Proposed amendment to GCU Appendix 9

Title:	Stopping/securing device for the plunger
Proposed amendment made by (RU/keeper/other body):	ERFA
Proposed amendment concerns:	<input checked="" type="checkbox"/> Appendix 9 <input type="checkbox"/> Appendix 11
Proposer:	Luca Mandelli, ERFA
Location, date:	Chiasso, 01/12/2023
Concise description:	Introduction of a new damage code for the plunger stopping/securing device

Images are provided below as examples of different types of plunger stopping/securing devices

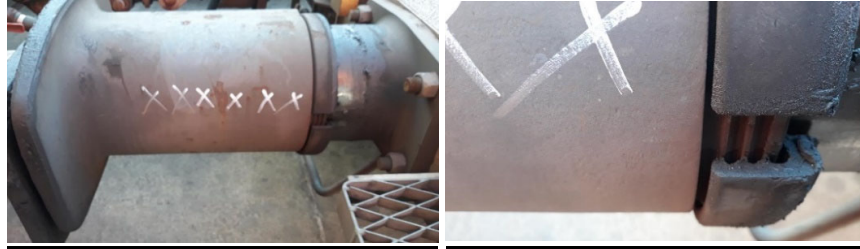
This defect occurs regularly during operation.

Appendix 9 and the wagon damage report have to specify/document this issue in more detail. This requires specific codes to be provided, and a corresponding code for the detected defect to be created.

Introduction of a new damage code 5.3.3.3 for the plunger stopping/securing device

Component	Code no.	Irregularities/Criteria/Notes	Action to be taken	Irregularity class
Plunger	5.3			
	5.3.1	Missing, broken	Detach wagon	5
	5.3.2	Cracked at the transition to buffer head	Detach wagon	5
	5.3.3	Operation jeopardised		
	5.3.3.1	Cracked longitudinally and no longer capable of guiding buffer casing	Detach wagon	5
	5.3.3.2	More than 2 grooves distributed over the circumference, each > 2 mm in depth, sharp-edged, and > 60 mm in length	Detach wagon	5
	5.3.4	Plunger stopping/securing device		
	5.3.4.1	Missing/does not work	Detach wagon	5
	5.3.4.2	Displaced	K	4
